U.S. Department
of Transportation
Federal Highway
Administration

In Reply Refer To: HSSD/B-183

Name of system:	Nu-Cable Systems – Use of Plastic or Steel Sockets Use of driven steel sockets
Type of system:	Cable Barrier
Test Level:	NCHRP Report 350 TL-3 and TL-4
Testing conducted by:	Holmes Solutions of New Zealand and Texas Transportation Institute
Date of request:	July 25, 2006

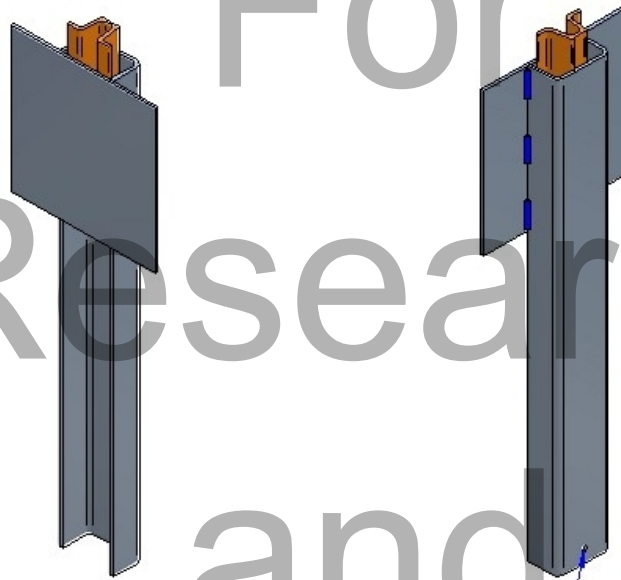
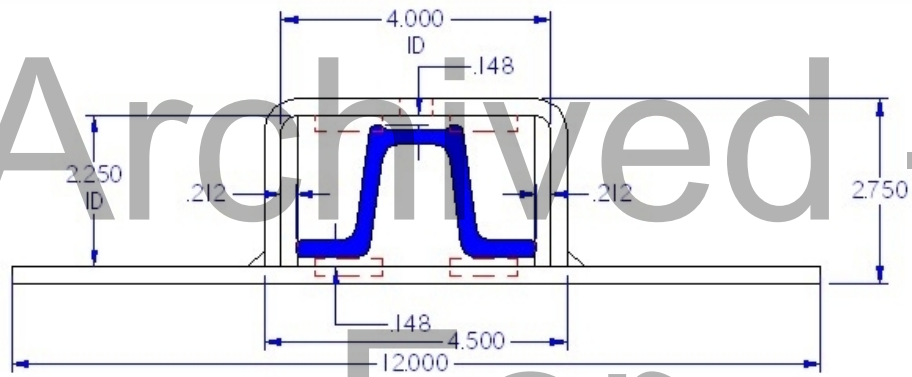
You also requested the use of driven steel socket sleeves for 4-pound-per-foot u-channel posts, as shown in the enclosed drawing. Informal vehicle testing in standard soil showed no perceptible movement of the socket.

- 1) Posts mounted in plastic socket sleeves encased in a rebar fortified concrete foundation,
- 2) Posts mounted in steel socket sleeves encased in a rebar fortified concrete foundation,
- 3) Posts mounted in driven socket sleeves with soil plates.
